90% PLAN REVIEW

Shake Shack – Oak Lawn, IL
4071 W. 95TH St.
Oak Lawn, IL 60453

National TAB
1126 Swift St.
North Kansas City, MO 64116

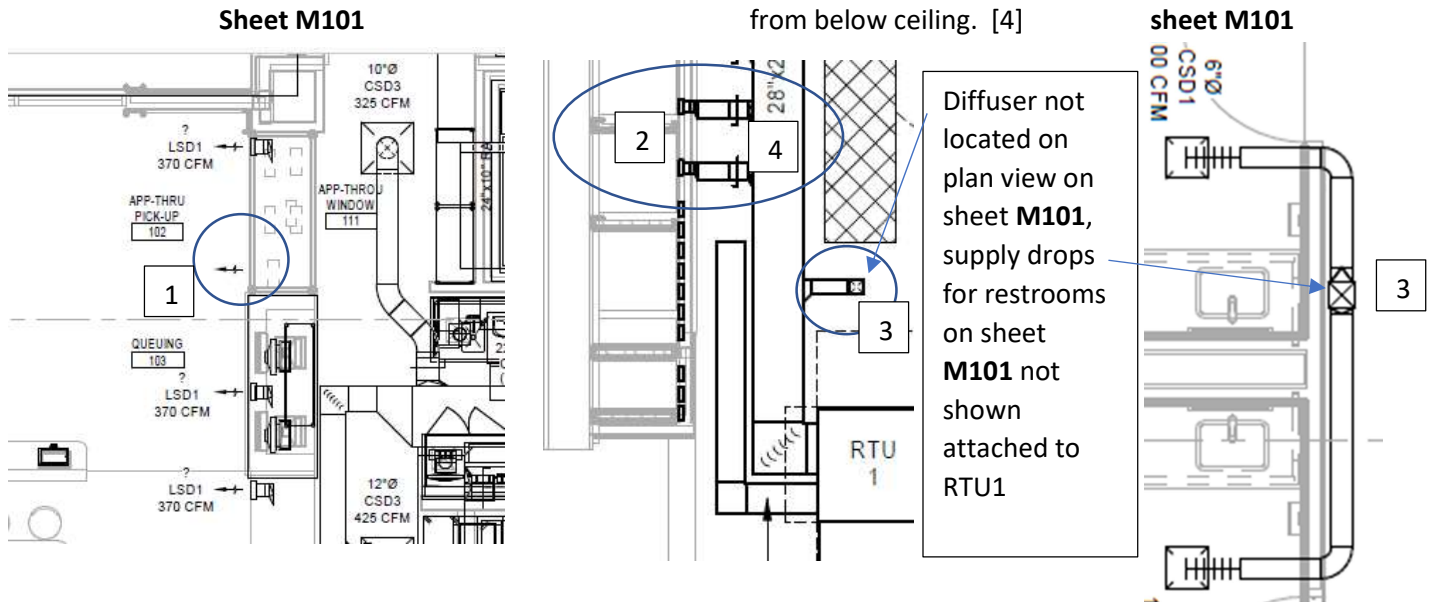
To be consistent insert “locking quadrant” in Note 21. **[Moved to note 18 & 19, corrected on sheet M001]**

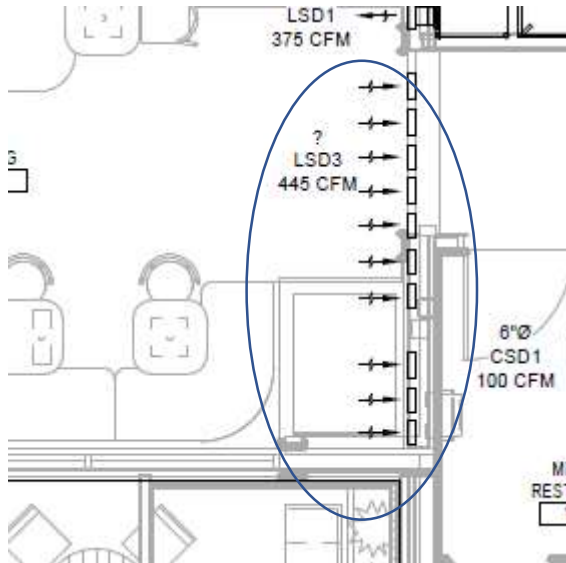
Sheet M150- damper at main – ensure access from below ceiling. [4]

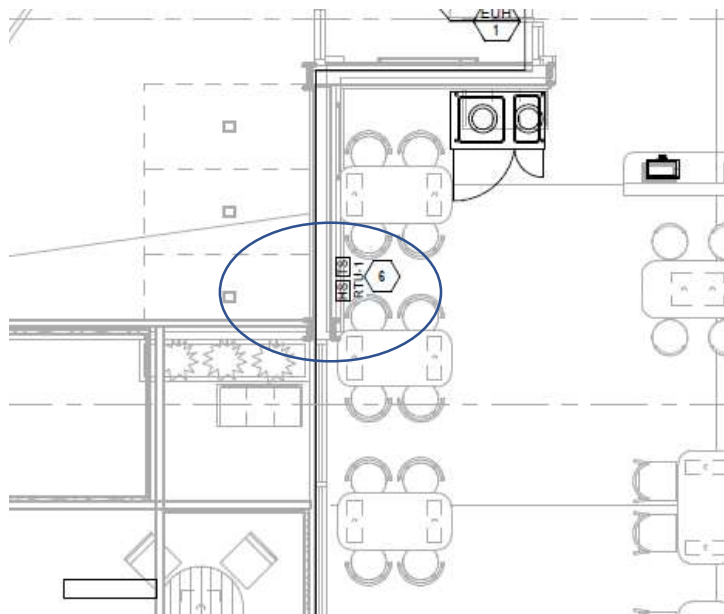
- Dining linear return slots not complete or shown with registers connected to branch/main return ducts, ensure diffuser branch ducts have accessible dampers (outside of any hard lid encase they are set shut or fail shut). **Addressed on M101 and M501 remoted damper detail**

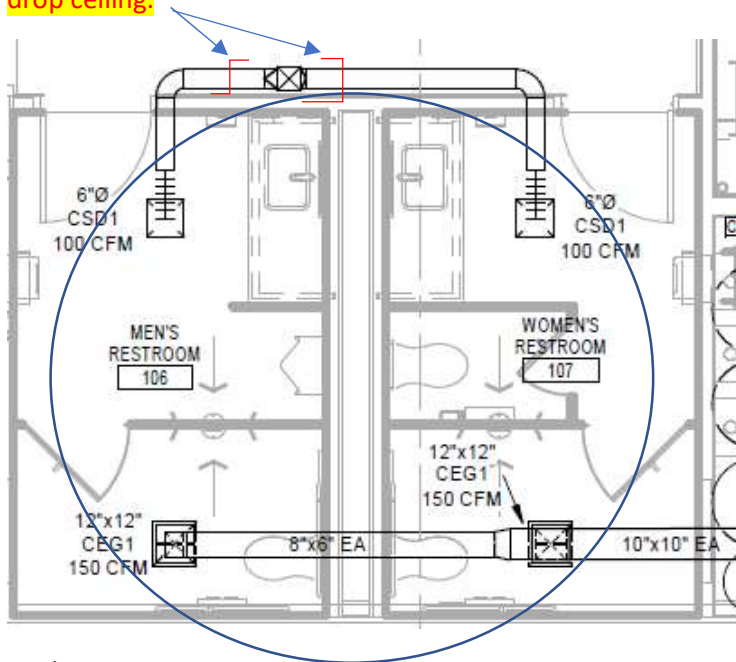
RTU-1 Suggest moving temp / humidity sensor to interior wall if possible or detail proper insulation from wall cavity and surface. Protect sensors from incidental contact since they are located between two customer tables. **Location moved on sheet M101 to interior wall near returns**

Kitchen RTU:

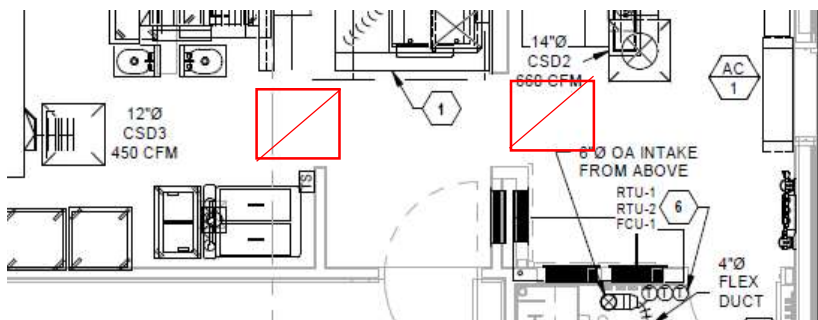
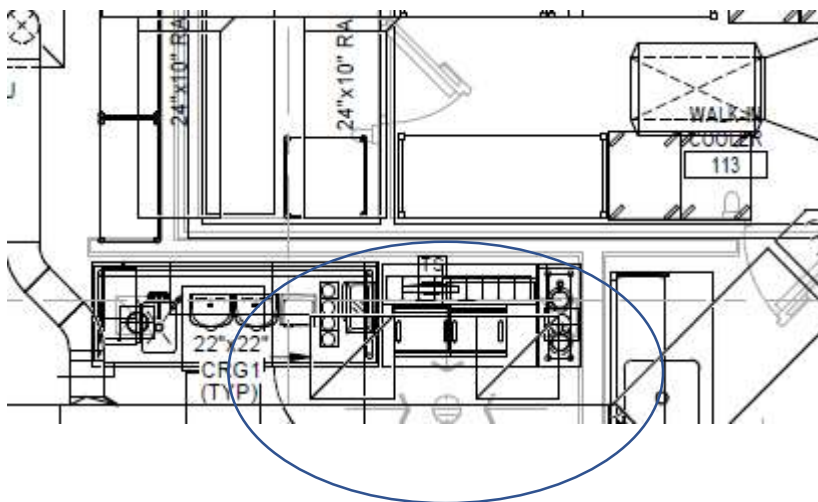
Appears to be open – plenum return. Only two open return openings are in back the of the kitchen near the walk-in cooler. We highly suggest open (or ducted) returns are distributed to both ends of the kitchen. If open return, prefer a small return plenum box be installed on top of any open return with damper to allow for distribution of return air path to prevent drafts across the hoods. Returns also need to be 10ft from exhaust hoods Sheet M101: Detail revised; Returns located behind hood wall so as to minimize cross drafts at the hood

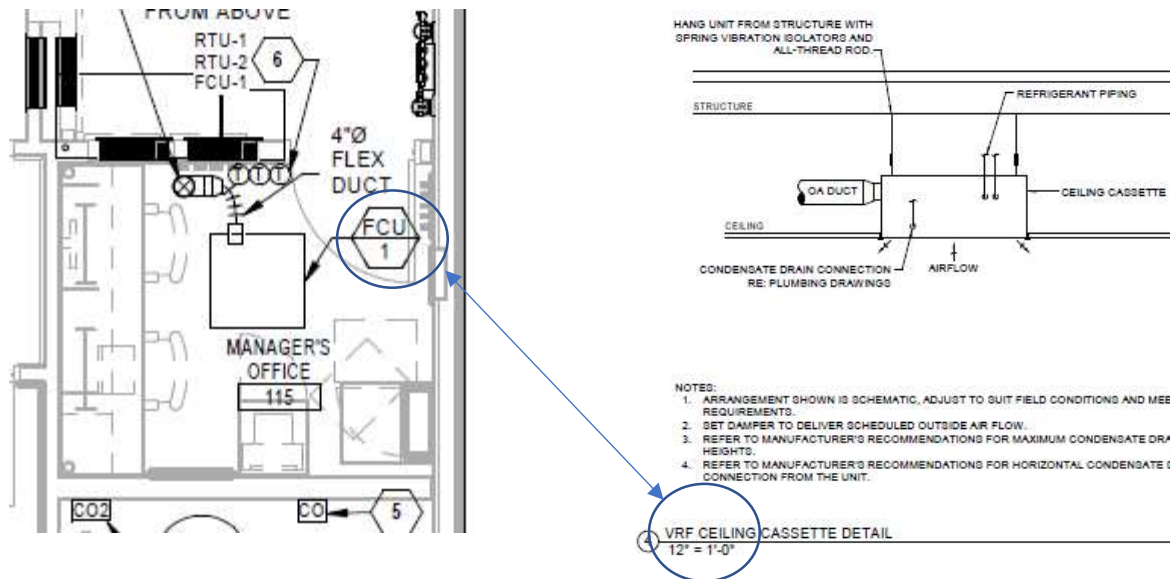
Fan coil accessibility details should be illustrated on plans, specific to blower, electrical, and filter compartments. Shall follow applicable code guidelines for accessibility. – **M501, detail – Note 1 should address this issue for accessibility.**

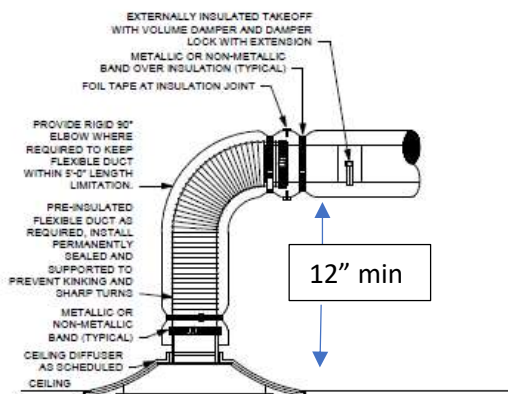
Consider showing 4" line damper in OA duct for fan coil-**M101 motorized shut-off damper included**

ROOF CURB DETAIL

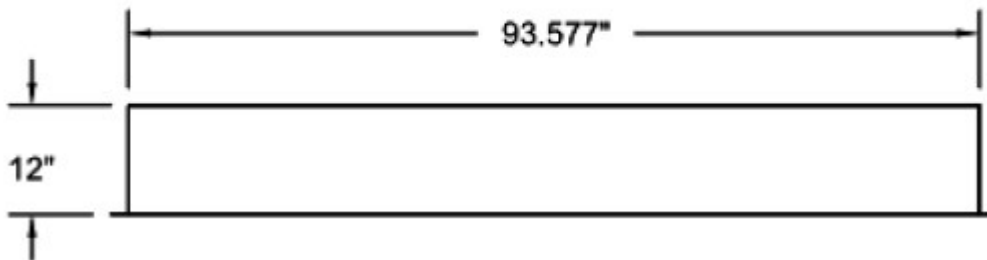
M701: MUA curb detail, consider increasing curb size from 12" height to minimum 18" height (MIN) to prevent snow packing in front of access doors. No change to detail – still shows 12" height curb. Is this acceptable considering insulation thickness on roof and potential snow pack

3 ITEM # 1-1, 1-2 SECTION VIEW

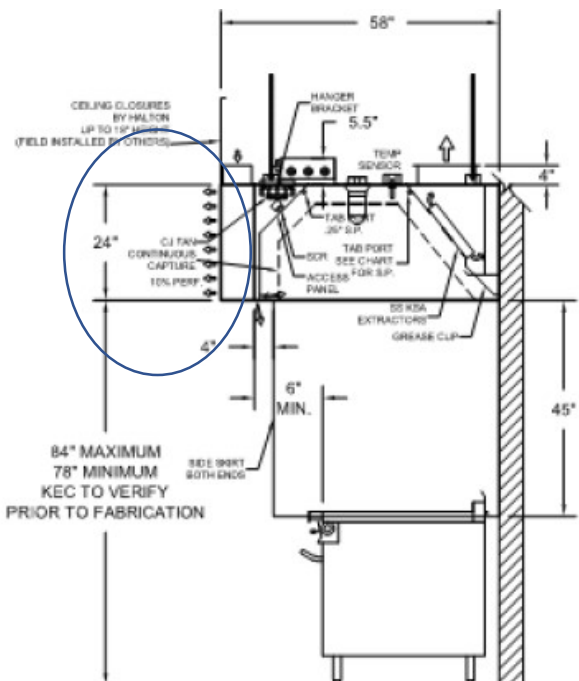
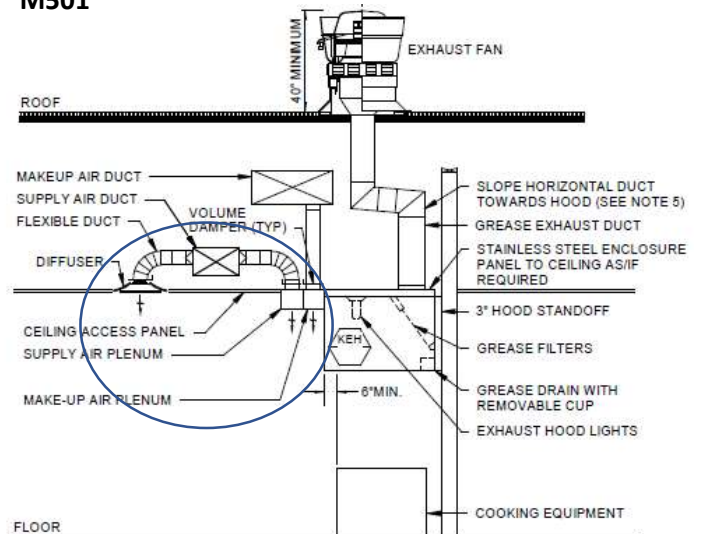
M702 Halton hood section detail differs from sheet M501 section detail. Planned supply plenum detail on M501 should match manufacturers supply orientation on M702. **Detail fixed on M501**

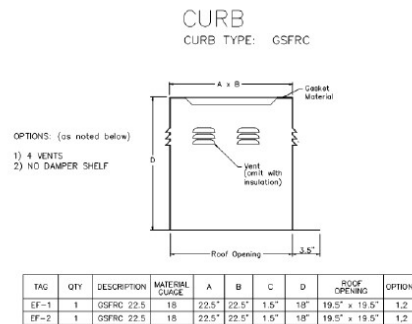
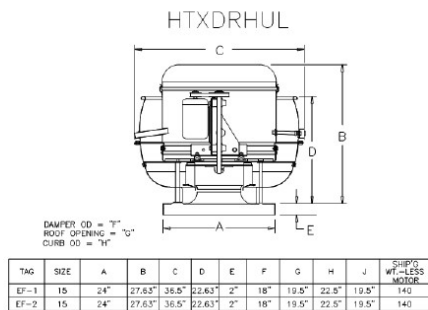
M704: Code requires discharge point of exhaust fan to be minimum of 40" above finished roof. Curb dimension "D" is 18" tall. Fan Dimension "D" is 22.63" tall. The total height is 40.63". This does not allow for securing curb directly to deck and being sunk below possible roof batting. **Suggest a 20" tall curb to ensure 40" clearance can be maintained. Corrected Detail 10 – M501, M704 does not show curb extension or curb height detail resolved – with insulation thickness on roof this may limit height of exhaust below code required 40" discharge height.**

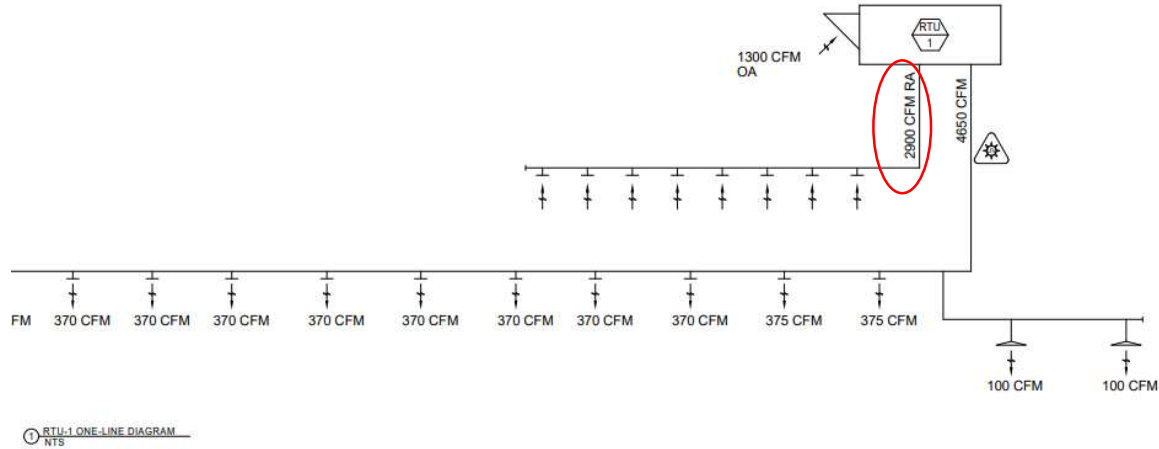
Change “Full Flood Ansul System” to Ansul’s proper terminology “Ansul R-102 Overlapping System” **Not corrected**

Note 1: Change “in accordance with R-102 installation manual” to “in accordance with Ansul R-102 overlapping system manual” **Not corrected**

Note 2: Change “wire rope” to “stainless steel cable” ” **Not corrected**

Add note prior to note 3: Fire suppression contractor shall have an additional trip for an onsite pretest with the general contractor, mechanical, plumbing, building alarm and electrical contractors prior to final suppression with local AHJ. Deficiencies shall be resolved by responsible trade before the final can be schedule. Test should be conducted at 3 days (minimum) prior to scheduled final. **Not corrected**

Add Note: All connections to the fire suppression low voltage and high voltage Ansul micro-switches must be made in a U.L rated Junction box outside of the Ansul automan compartment to keep from voiding the listing of the Ansul system. **Not corrected**

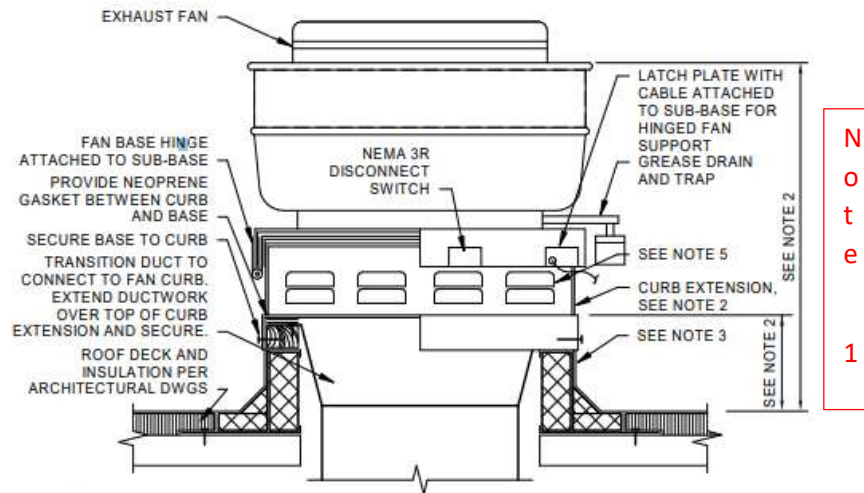
New 90% review comment. M502: Change RTU-1 Return air from 2,900 to 3,350

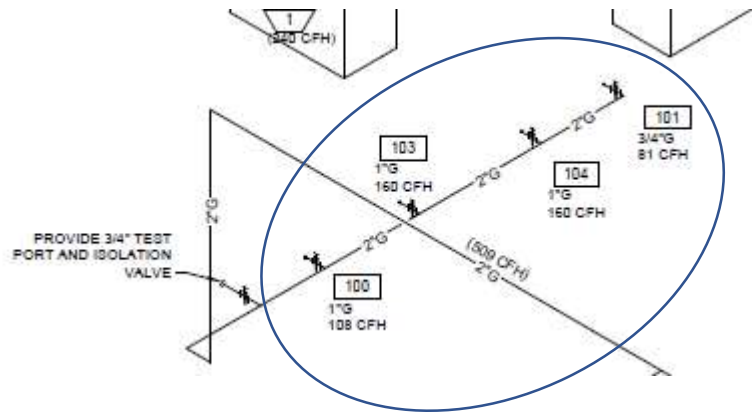
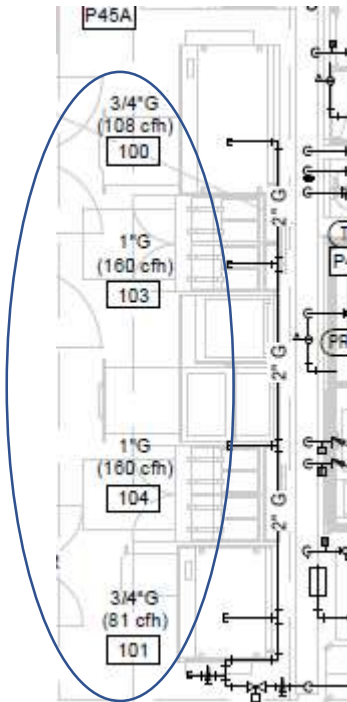
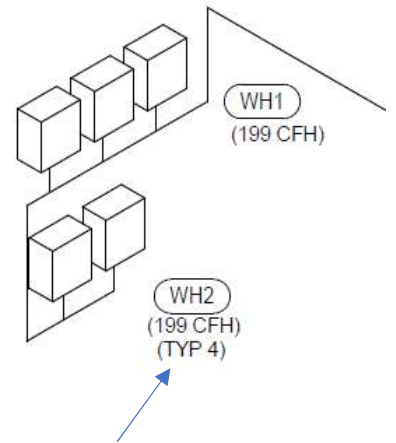
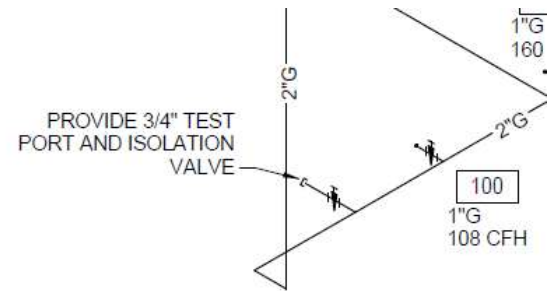
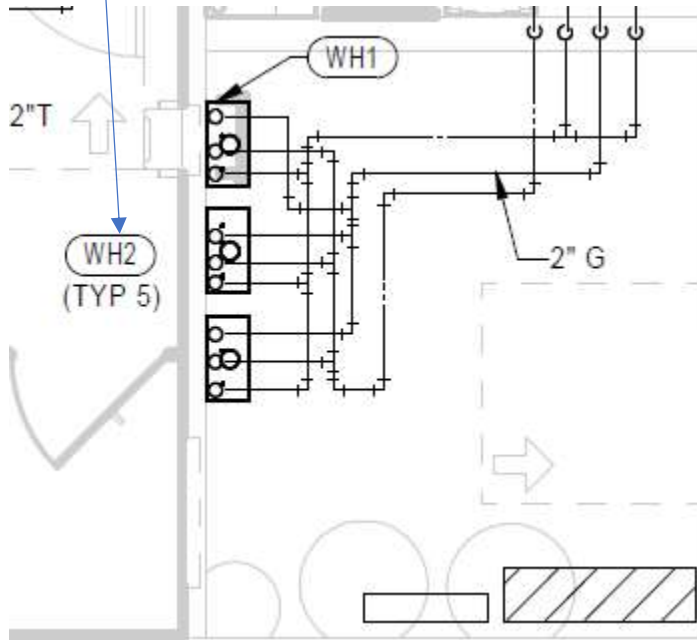
P120 and P901: Cook line gas connections per item are shown in reverse order from each other when comparing sheet P120 and sheet P901. Need to validate connection order to sequence properly on each sheet – **sheet P901 has been corrected to match P120 tag orientation**

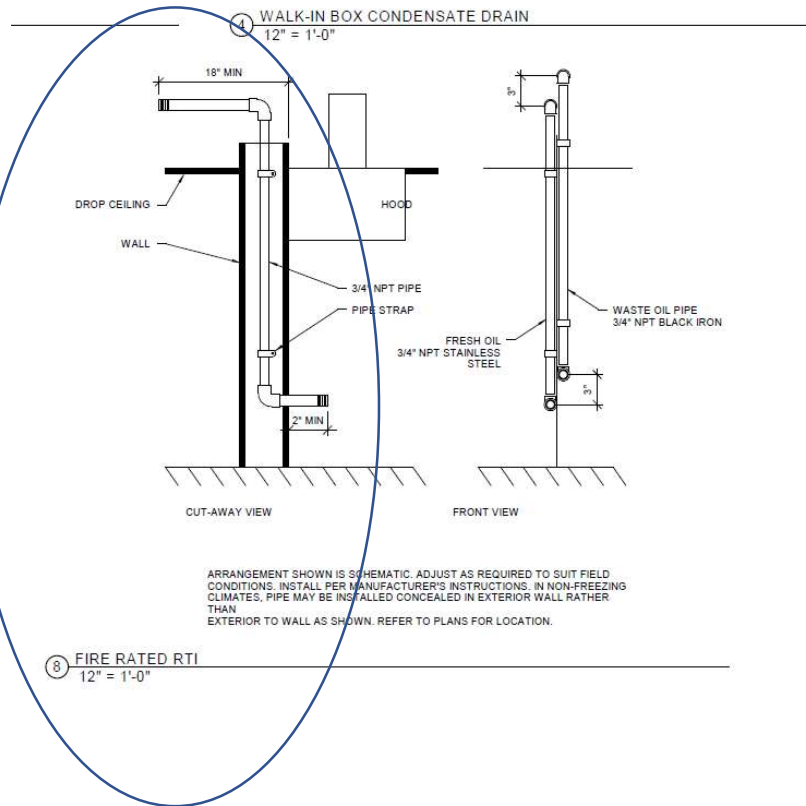
Water heater – **P120**: water heaters shown – note indicates WH2 (TYP 5)

Detail **P901** (left) shows Two water heaters WH2 shows TYP 4 which differs from comment on P120 (above)

Sheet P120 has been updated to show (typ 4) to match detail on sheet P901

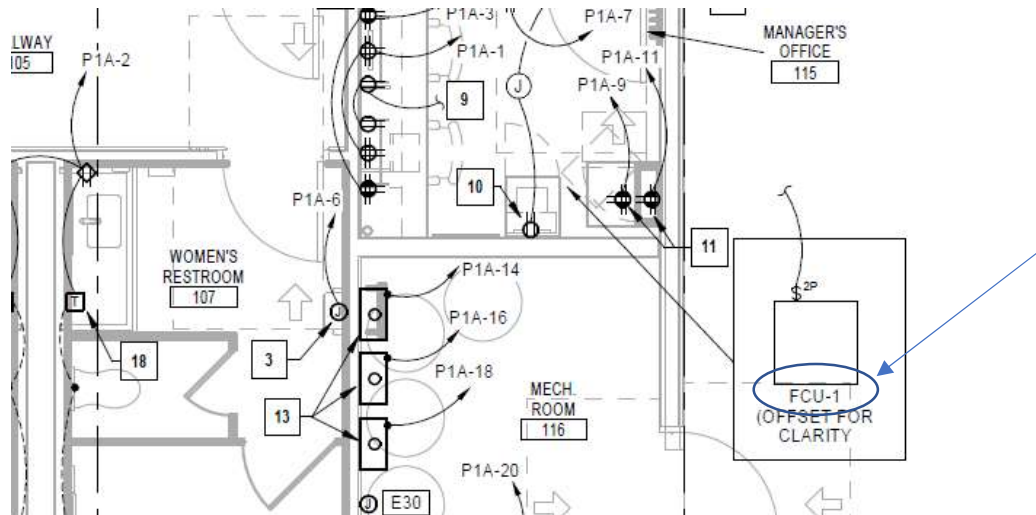
E101 – note 5 references note 7, seems to imply that it should reference note 6

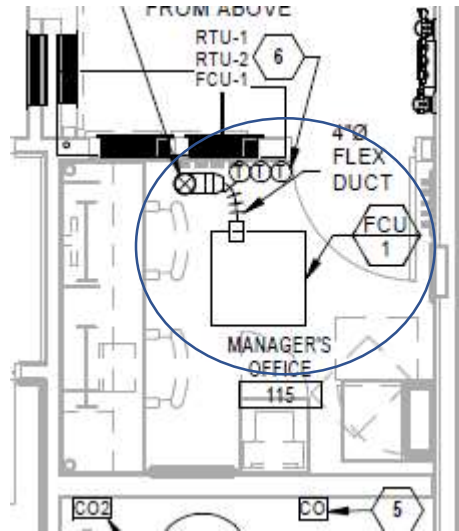
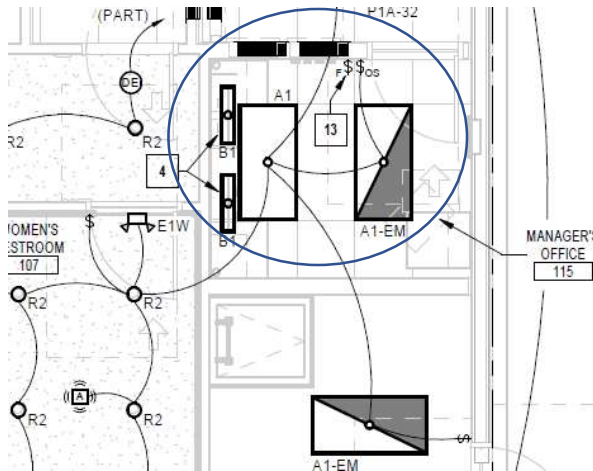
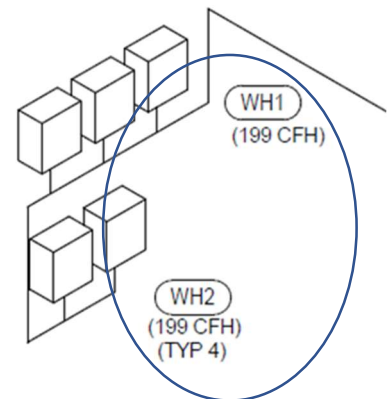
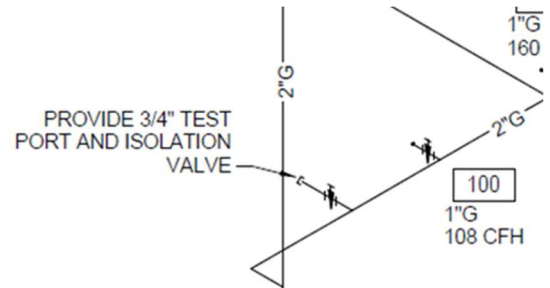
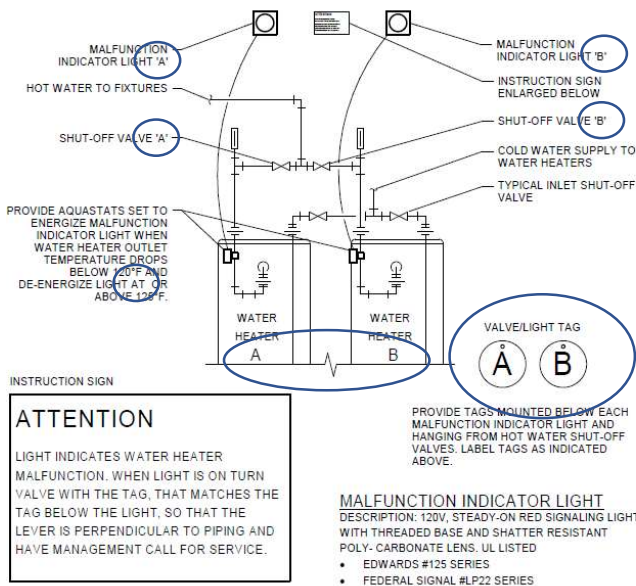
E120 – Manager’s office emergency Light and VRF cassette Cartridge (sheet M-101) should be coordinated by contractors or shown to ensure they do not infringe on each other’s required location. No apparent change – **Need to avoid collisions based on ceiling tile layout, no change to current details on this issue. I would suggest noting ceiling grid to allow room between emergency light and room light for FCU-1. I believe this unit is slightly larger than 24” square so that row of ceiling grid may be wider. Please confirm.**
